# Supplemental Design Investigation Sampling Plan - Revision 1

Northern Impoundment
San Jacinto River Waste Pits Superfund Site

Table 1 Response to Comments - Supplemental Design Investigation Sampling Plan

**Response to Comments – Supplemental Design Investigation**
**Northern Impoundment**
**San Jacinto River Waste Pits Site**
**Harris County, Texas**

FIGURE 2

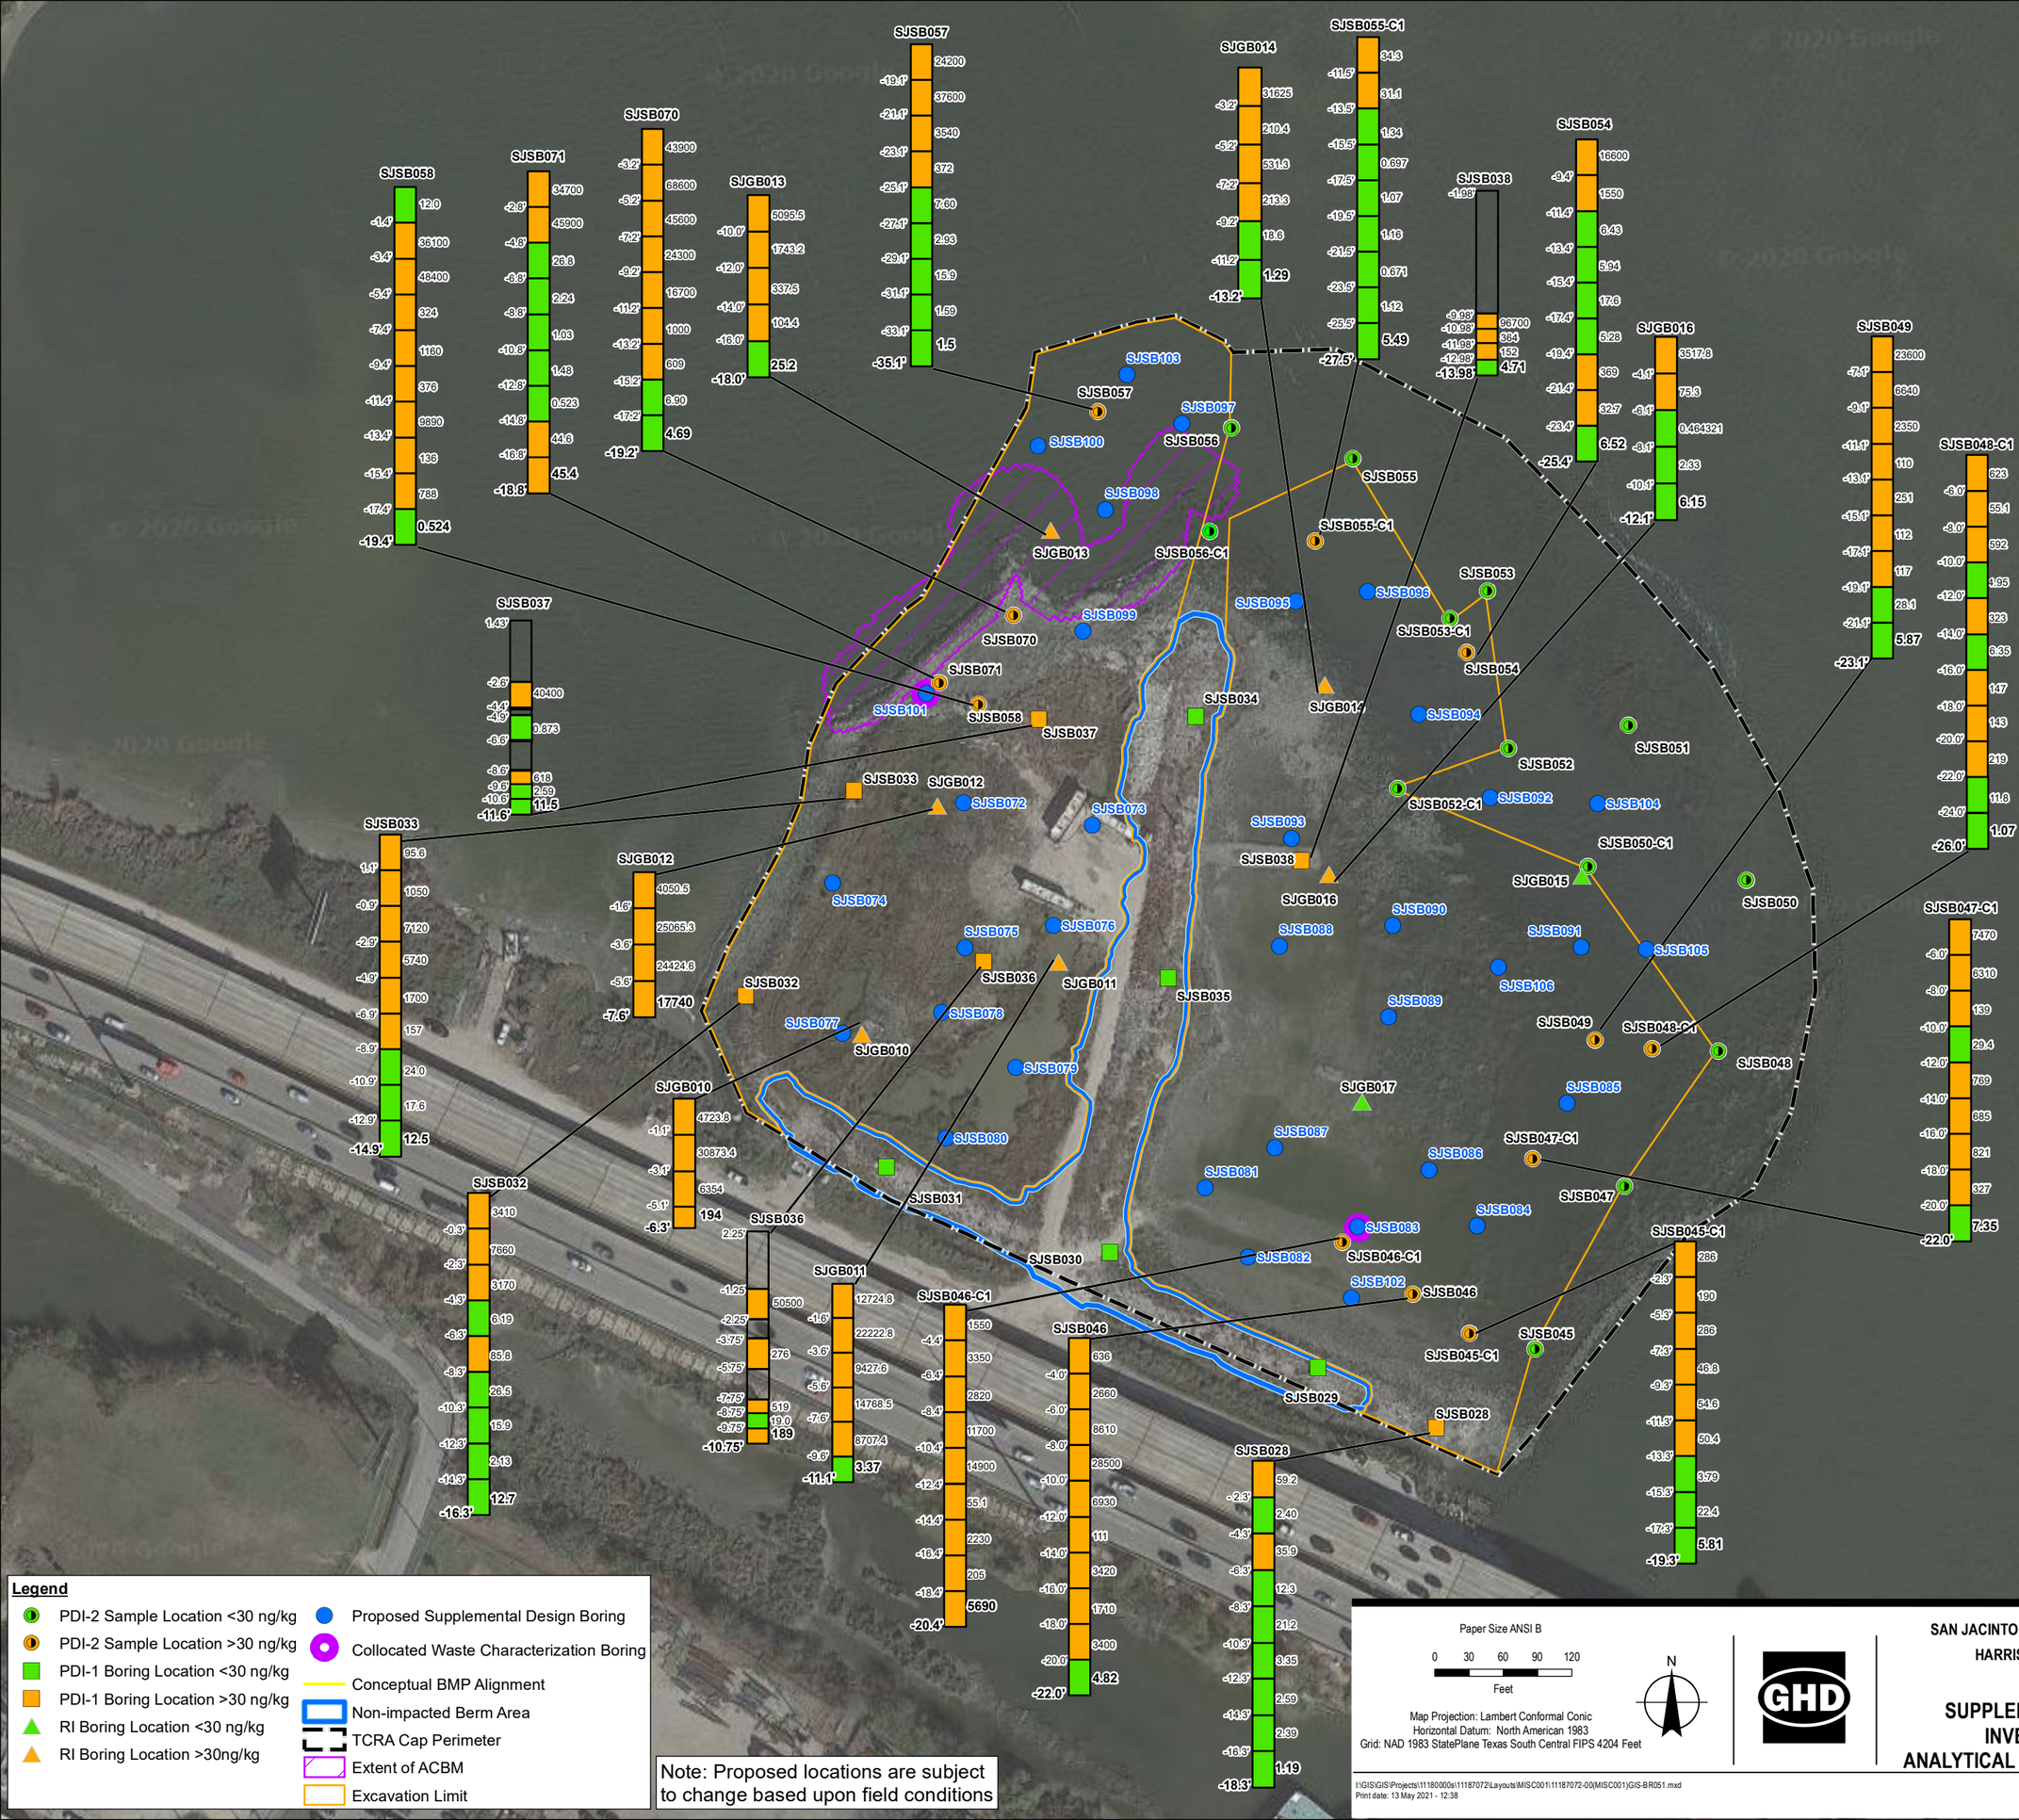
| Item No. | Reference | Comment | Response |
|---|---|---|---|
| 4 | Section 2.0, Figure 2 | Conduct more extensive delineation at the deep northwestern corner of the removal area and surrounding the articulated concrete block mat (ACBM). | In the Sampling Plan, the spatial coverage of the proposed borings in the northwestern corner was the same as the spatial coverage in the rest of the Northern Impoundment (approximately one boring per 1/4 acre, when historic and proposed borings are combined). It should be noted, however, that due to significant water depths in this area, a different drilling method may be required that will be extremely challenging to utilize and poses logistical and safety-related risks.<br><br>In response to this comment, the Respondents have added three boring locations (SJSB100, SJSB101, and SJSB103) in the northwestern corner in the vicinity of the ACBM to further delineate this area. The boring locations are shown on Figure 2. |
| 5 | Section 2.0, Figure 2 | Conduct more extensive delineation in the southeast corner of the site in the vicinity of cores SJSB046, SJSB046-C1, and SJSB047-C1. | The proposed soil borings in the southeastern corner of the Northern Impoundment have been adjusted and an additional boring location (SJSB102) has been added between historic borings SJSB046 and SJSB045-C1 to further delineate this area.<br><br>The boring locations are shown on Figure 2. |

| Item No. | Reference | Comment | Response |
|---|---|---|---|
| 6 | Section 2.0, Figure 2 | Supplemental borings are required as part of this sampling event if previous borings did not reached TEQ levels < 30 ng/kg. | As stated in the response to Analytical Sampling Comment 1 above, there are five historic sample locations (SJGB010, SJGB012, SJSB036, SJSB046-C1, and SJSB071) where TEQ levels < 30 ng/kg were not observed at the terminal depth of the boring. The initial submittal of this Sampling Plan included proposed borings adjacent to each of these historic borings, with the exception of SJSB071. A proposed boring location (SJSB101) has been added adjacent to SJSB071 such that now there will be a collocated boring installed beside all five of these historic boring locations as part of the Supplemental Design Investigation. With the exception of borings SJSB083 and SJSB101 which will be analyzed for waste characterization purposes, the Respondents will only analyze the samples in the collocated borings that are deeper than the terminal depth of each historic boring with TEQ levels > 30 ng/kg (e.g. at proposed boring location SJSB072, the first sample analyzed would be the interval from 8 - 10 ft bgs, because collocated historic boring SJGB012 had a TEQ level > 30 ng/kg at its terminal depth of 8 ft bgs).<br><br>The text in Section 2.1.1 of the Sampling Plan has been updated accordingly. The planned sample intervals are detailed in Table 2. The boring locations are shown on Figure 2. |
| 7 | Section 2.0, Figure 2 | Some of proposed supplemental borings are close to a PDI-2 sample location showing contamination as opposed to equally spaced between two PDI-2 sample location showing contamination, such as SJSB085 and SJSB076, despite the adjacent core having reached clean. Review these sample locations. | The number and locations of the proposed borings have been adjusted in accordance with the boring placement specified by the EPA in email correspondence dated May 9, 20201.Borings moved or added at the EPA's direction appear to be investigative in nature and the Respondents do not regard the addition of these borings to be necessary or appropriate to inform the 90% RD.<br><br>The adjusted boring locations are shown on Figure 2. |
